NINE MILE POINT
NUCLEAR STATION

Response to Request for Additional Information Regarding Nine Mile Point Nuclear Station, Unit No. 2 – Re: The License Amendment Request for Extended Power Uprate Operation (TAC No. ME1476)

**RESPONSE TO REQUEST FOR ADDITIONAL INFORMATION
REGARDING LICENSE AMENDMENT REQUEST FOR EXTENDED
POWER UPRATE OPERATION**

Figure EMCB-31-1. Extraction Paths for Linearized Stress Results

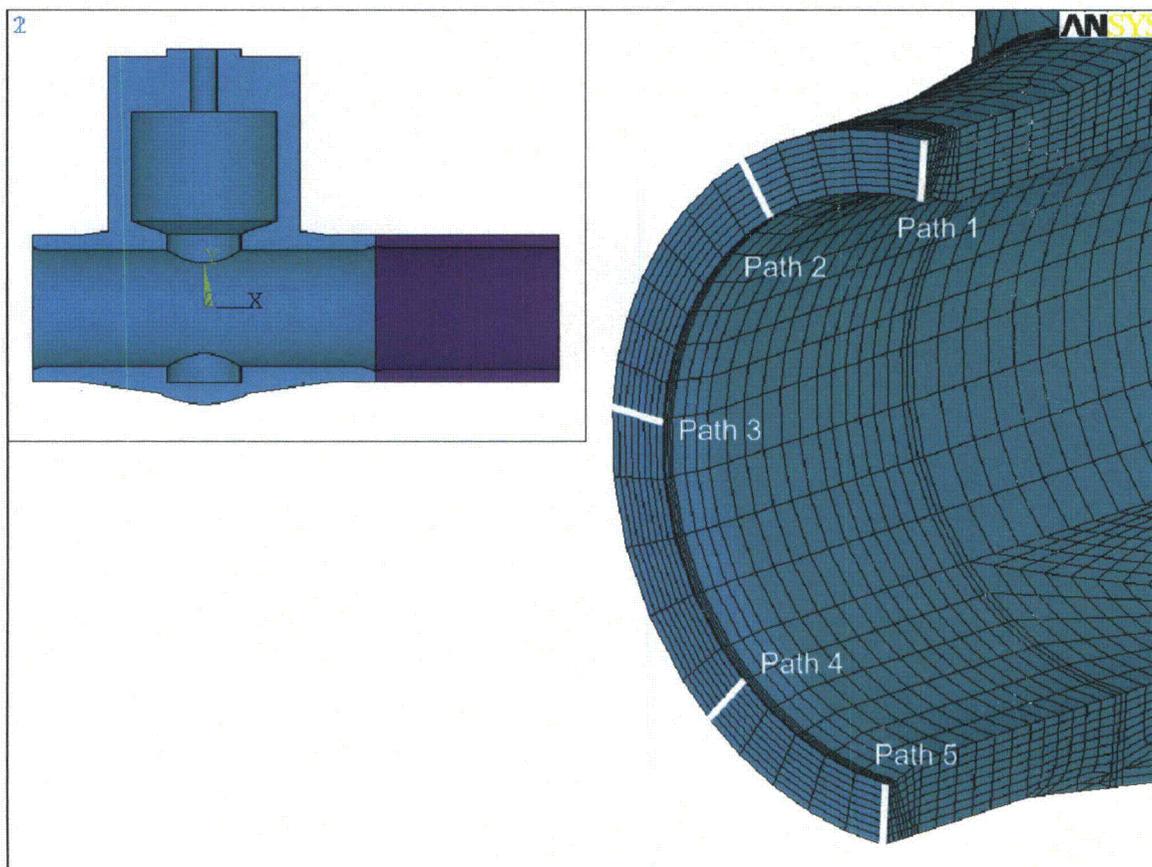
- a) *In the current design basis of the plant, are there any piping analyses that contain stratification and is there any CLTP stratification monitoring currently in place? Please list these stratification locations.*
- b) *Explain how these stratification locations have been evaluated and accepted for the EPU conditions and provide a summary of their evaluation results.*

MOV21B located on feedwater loop B (Line 2-FWS-024-28-4 for Class 4 and Line 2-FWS-024-51-1 for Class 1) is a location subject to thermal stratification monitoring which required supplemental finite element modeling and revised thermal cycle definition to address the EPU scaling factor. This location is a break exclusion zone where fatigue usage is required to be maintained less than 0.1. A solid, half section finite element model (FEM) including a portion of feedwater piping on the inlet and outlet side of the valve was used. The valve model comprises of the flow path, the body, and the bonnet (solid element type). The area of interest is the inlet-to-valve weld region. Static, transient, and stratification loading are applied to the FEM and stresses extracted from the area of interest for input to the fatigue analysis.

The maximum 40-year CUF calculated for the feedwater valve MOV21B is 0.0664 and is located at the inside surface of Path 1, see Figure EMCB-31-1. This value meets the ASME Code allowable value of ≤ 0.1 for break exclusion areas. Therefore, the feedwater valve is acceptable for 40 years of operation, including 20 years of EPU operation. For the 60-year license period, the calculated CUF value exceeds 0.1. Fatigue monitoring of the feedwater MOV21B location using the FatiguePro fatigue monitoring software is anticipated to be adequate to maintain the margin below 0.1 for 60-year license period. If fatigue-monitoring trending predicts that fatigue usage cannot be maintained below 0.1, then corrective actions such as re-analysis, enhanced inspection, or repair/replacement will
